Report: PRELIMINARY TAB REPORT

Function: Test, Adjust, & Balance

Date: 10/17/2024

10-14-24 ULTA 1697 SELMA, NC

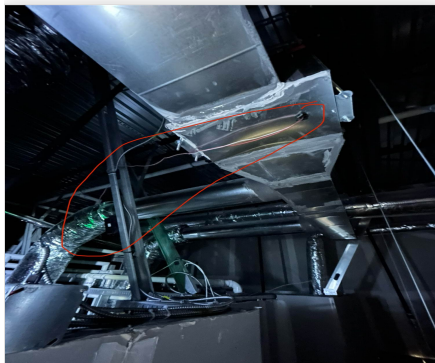
Issue Name : EF-2 Dampers not installed
Description : EF-2 dampers are not installed. However the airflows are proportional so they likely will not be required.
Created By : National TAB **Assigned To :** National TAB - Dan Hertenstein
Status : Open
Priority : Low **Asset Tag :** EF2
Originated Date : 10/17/2024 - Will Turnbough - National TAB

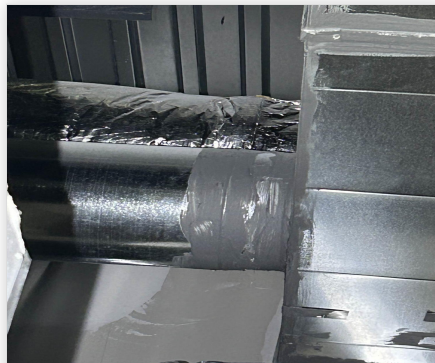
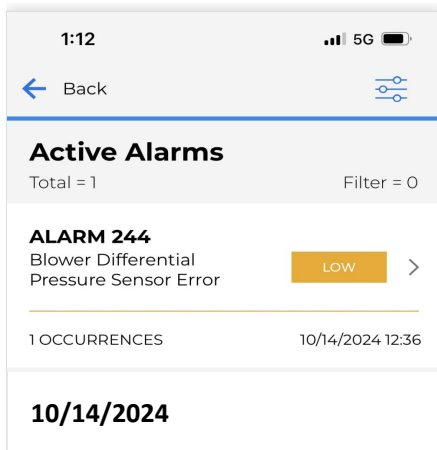
Issue Name : EF-2 Restroom fan unable to access
Description : EF-2 speed controller is located above hard ceiling and is inaccessible. Unable to reach from other side with ladder due to piping obstructing access. The unit is running at 117% of design.
Created By : National TAB **Assigned To :** National TAB - Dan Hertenstein
Status : Open
Priority : High **Asset Tag :**
Originated Date : 10/14/2024 - Jearod Ferrette - National TAB

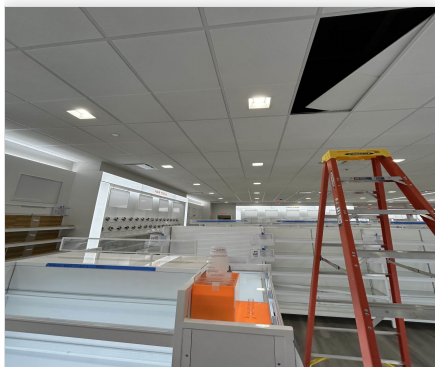
Issue Name : RTU-1 airflow is 84% of design
Description : RTU-1 airflow is 84% of design. The pulley cannot be increased further without the belt sitting too high up on the pulley. A pulley change is recommended.
Created By : National TAB **Assigned To :** National TAB - Dan Hertenstein
Status : Open
Priority : High **Asset Tag :** RTU1
Originated Date : 10/15/2024 - Jearod Ferrette - National TAB
